Planning Application No. A/YL/319 - Location of Proposed Run-in/out and the Existing Lamppost

(1) TD's comments on the location of proposed run-in/out and existing lamppost:

(2) Proposed run-in/out extracted from the revised TIA (Figure 2.2):

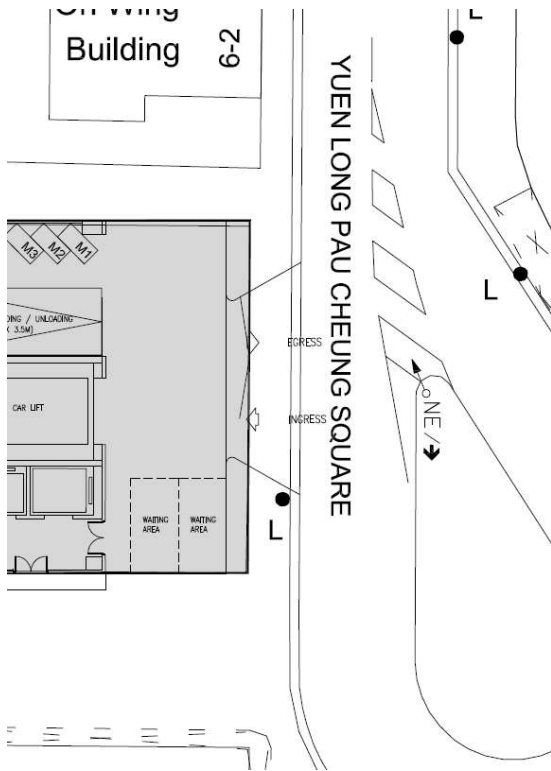
(q) Figure 2.2: The location of run-in/out is close to the existing lamppost, please seek comment from Highways Department;

1. The proposed works shall not disturb, interfere with or damage the public lighting facilities (i.e. lamppost no. FC4715 and associated lighting cables).

2. The applicant shall submit the lighting works proposal supported by lighting simulation to this Division for consideration if there are any proposed modification works to the existing public lighting system or new lighting works involved in the project. The lighting proposals shall comply with the latest Public Lighting Design Manual and Standard Drawings of the Highways Department. The cost for the relevant works should be funded by the applicant.

3. The details of public lighting duct crossing at run-in/out shall refer to Lighting Division Standard Drawings.

(2) Proposed run-in/out extracted from the revised TIA (Figure 2.2):

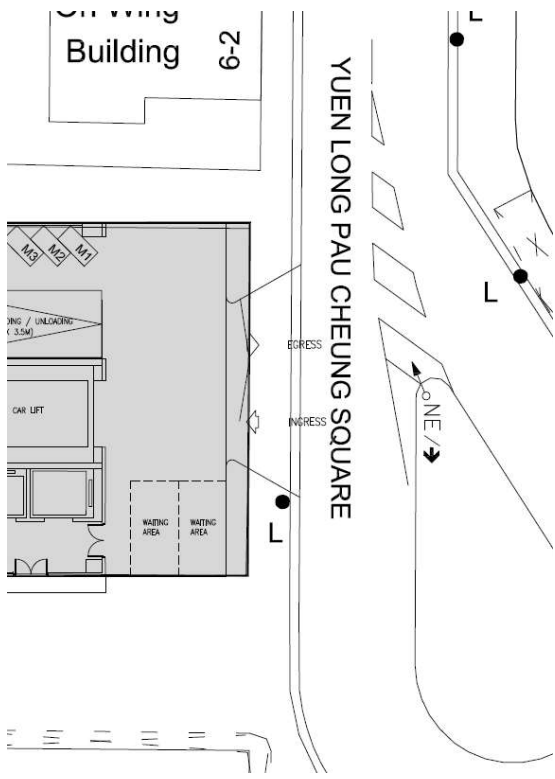
(q) Figure 2.2: The location of run-in/out is close to the existing lamppost, please seek comment from Highways Department;
